**Spartan RSB05-400-001
NHTSA Recall No. 05V-146**

RSB05-400-001B

RECALL SERVICE BULLETIN

SUBJECT: Ametek NGI Air Pressure Dash Indicator Calibration

FIG. 2-1

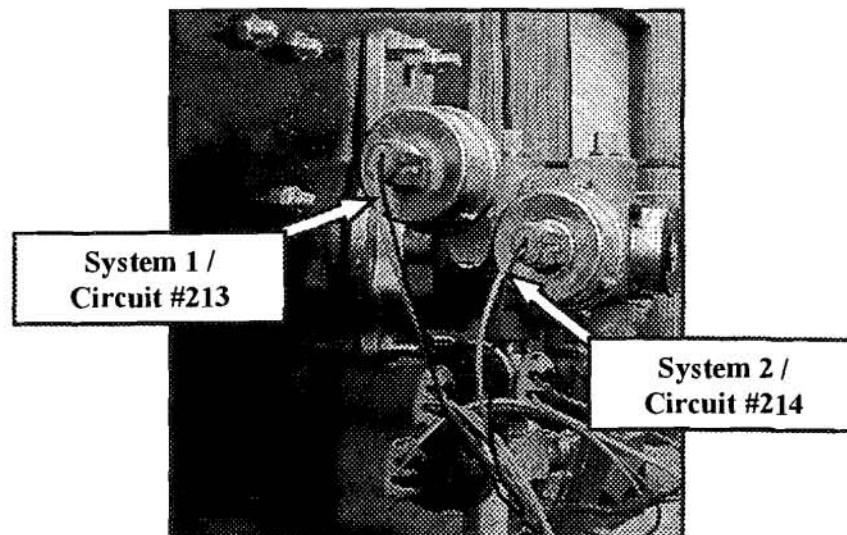
1. Observe all industry safety standards and secure vehicle to allow for disconnection of the air senders at to the front of the treadle assembly.

NOTE: Disconnect ONLY ONE sender at a time to ensure proper reconnection.

FIG. 3-1

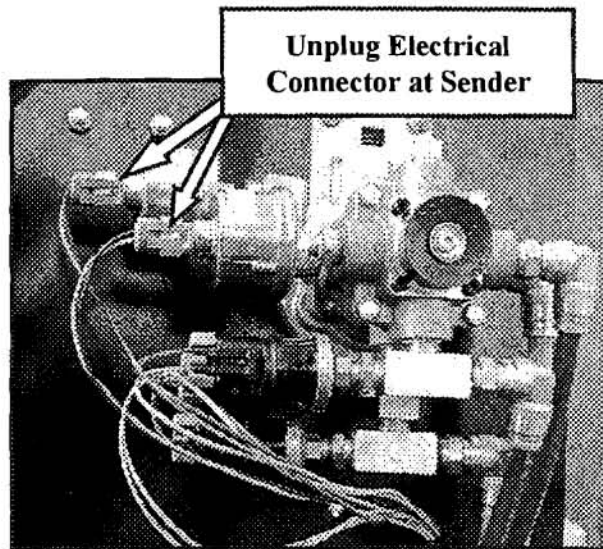
2. Refer to FIG. 3-1. Locate air senders at the front of the treadle assembly mounting plate.

NOTE: Disconnect ONLY one sender at a time to ensure proper reconnection.

3. Unplug electrical connector at one sender, plug one jumper harness from kit into the sender.
4. Plug electrical connector (previously unplugged from sender) into the jumper harness.
5. Repeat steps #3 and #4 for the remaining sender circuit.
6. Test the operation of the air pressure indicator in the dash.
